CHANGE ORDER NUMBER: 7

Project: 1810-265
Roadway: North Mays Ext
CSJ Number:

**Change Order No. 7**

**NORTH MAYS EXTENSION  
 UNDER BRIDGE  
 RE-VEGETATION PLAN**

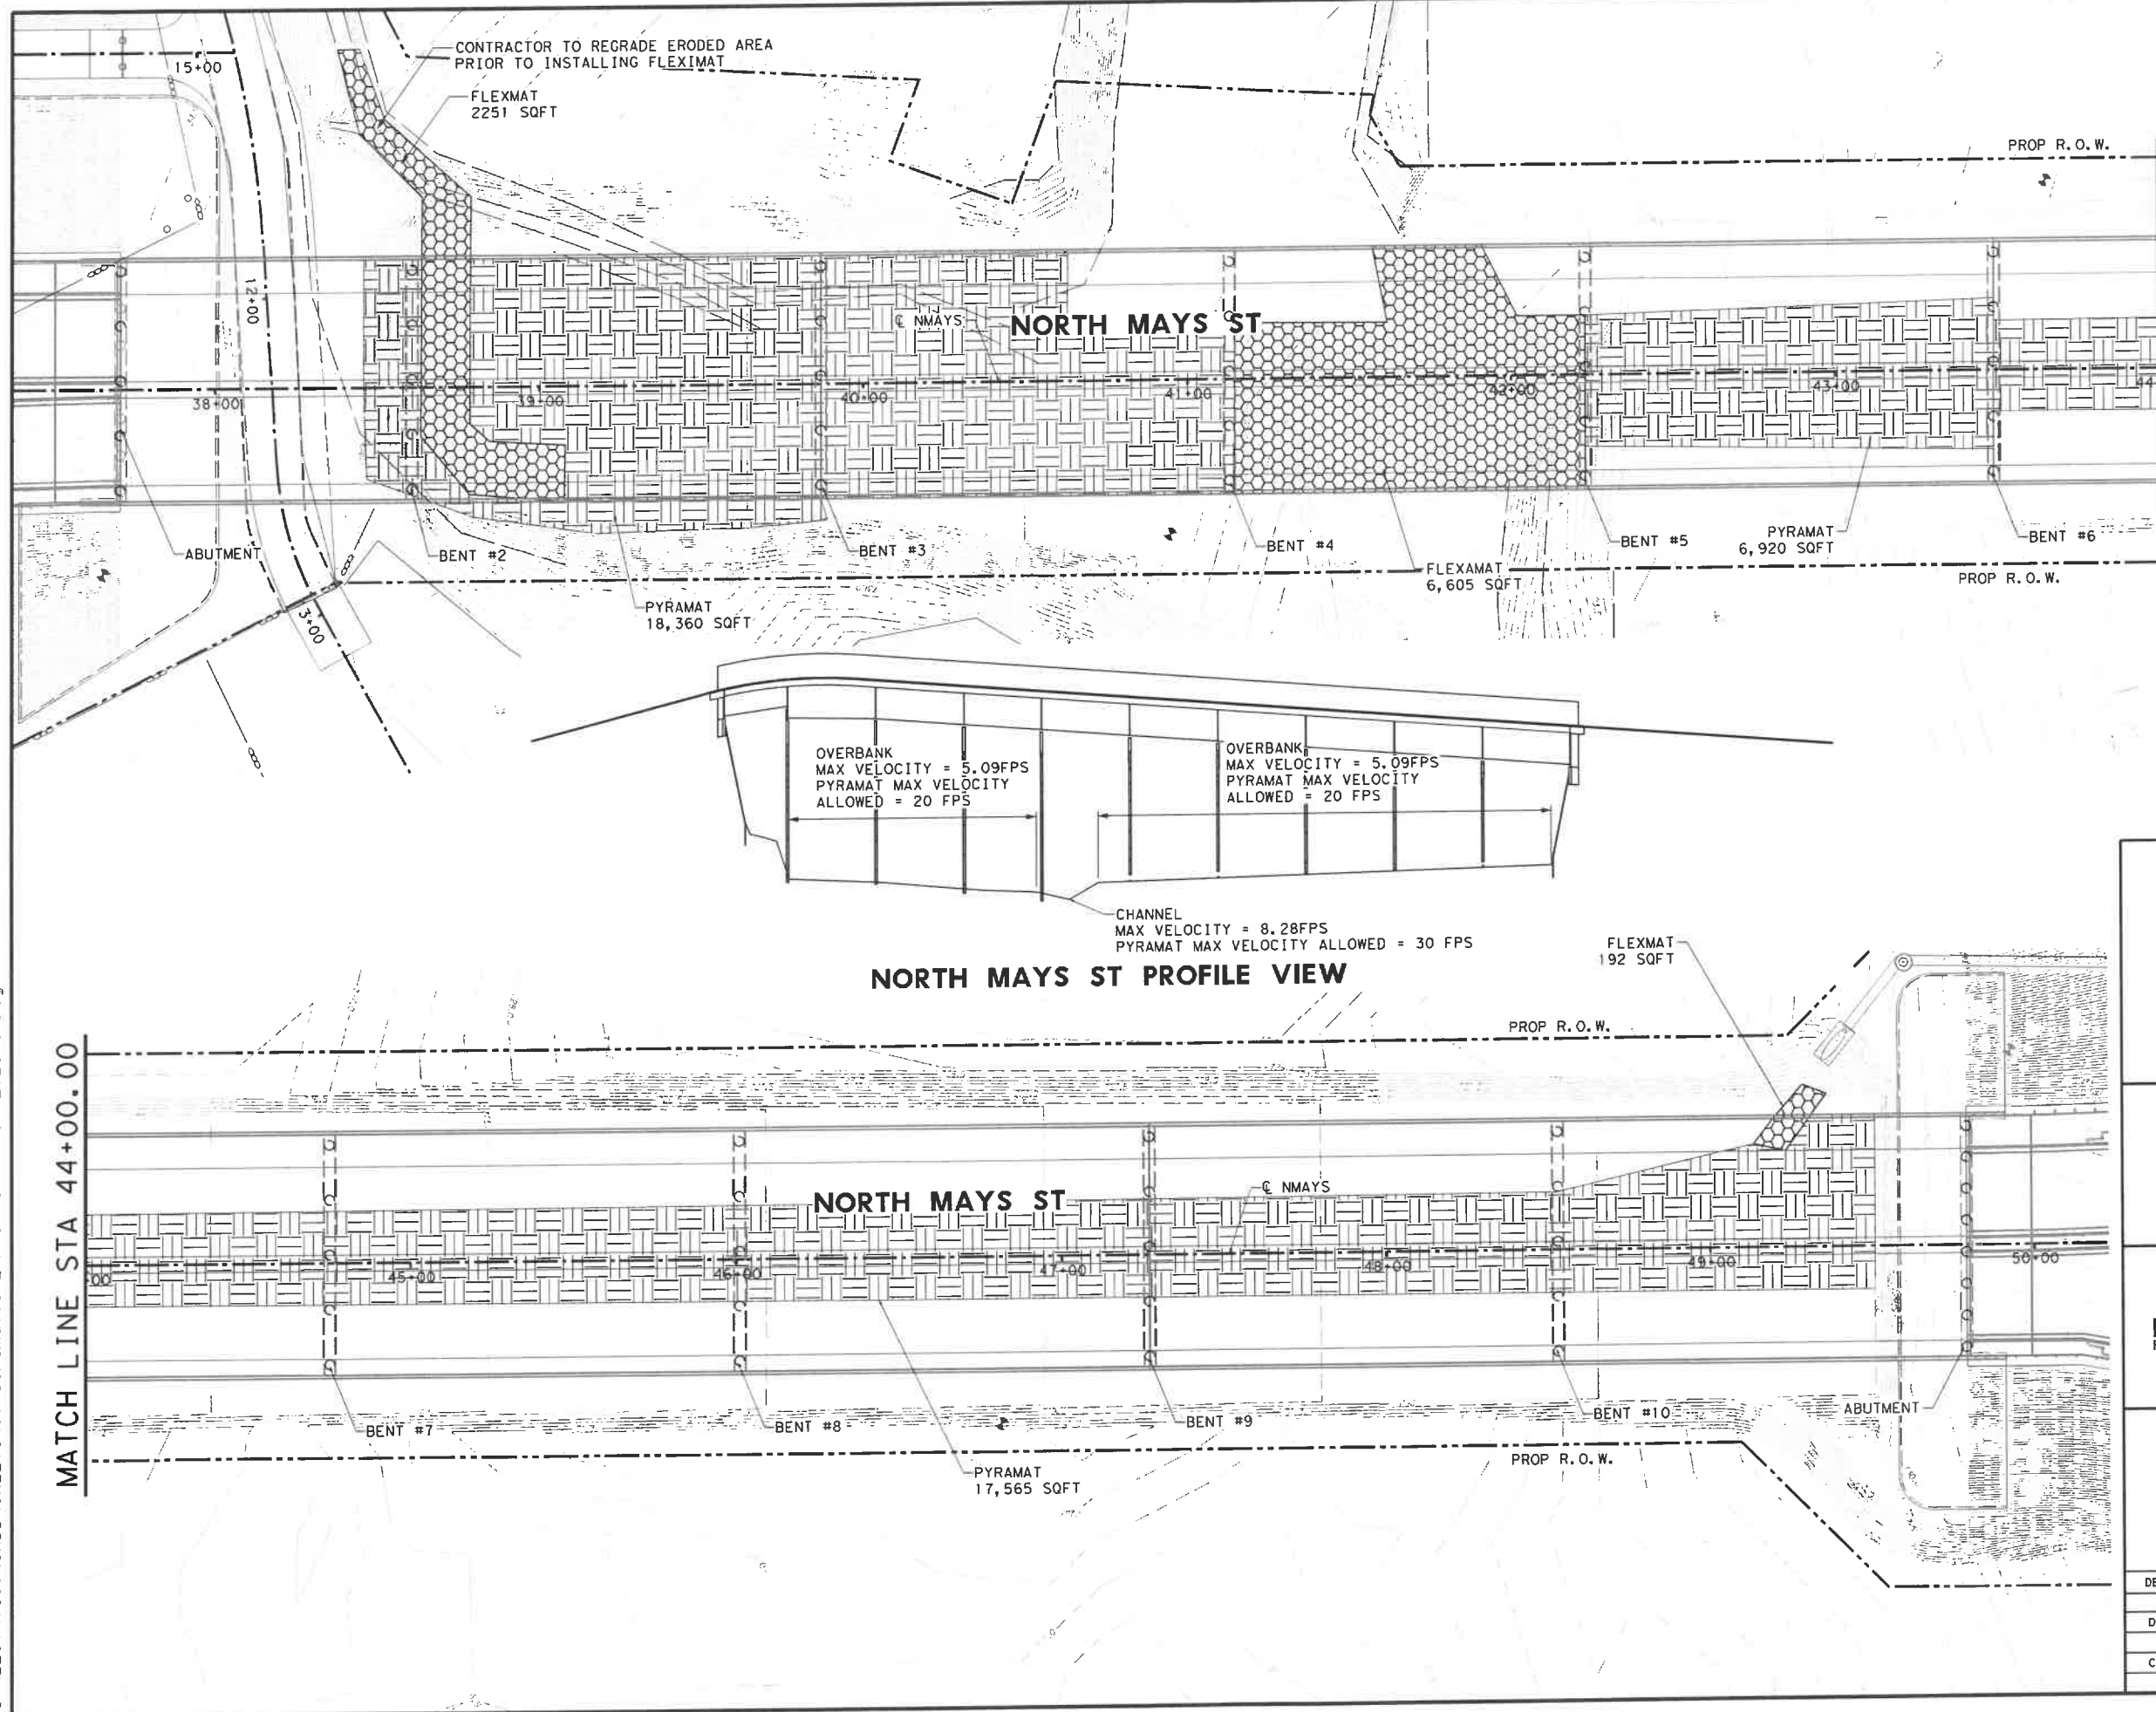
Due to the lack of exposure to sunlight and rainfall, vegetation did not establish under the bridge. To provide stabilization, heavy soil retention materials are being added to prevent erosion from drainage under the bridge. The plans and materials have been reviewed and approved by the City of Round Rock and the Water Control and Improvement District (WCID).

Item 999-WC09 Flexamat. This item pays for the soil stabilization materials to be installed under the bridge. Flexamat will be placed in the areas of the highest flows of water to prevent erosion.

Item 999-WC10 Pyramat. This item pays for the soil stabilization materials to be installed under the bridge. Pyramat will be placed in the remaining areas to prevent sediment loss.

- NOTES:
1. PYRAMAT AND FLEXAMAT SHALL BE PLACED IN ACCORDANCE WITH THE MATERIAL SPECIFICATION PROVIDED.
  2. ALL PYRAMAT SHALL INCLUDE GRASS SEED MIXTURE PLACED UNDER THE MAT. SEED MIXTURE SHALL BE APPROVED BY THE COUNTY.
  3. VELOCITY INFORMATION IS FOR THE 100-YEAR STORM EVENT.
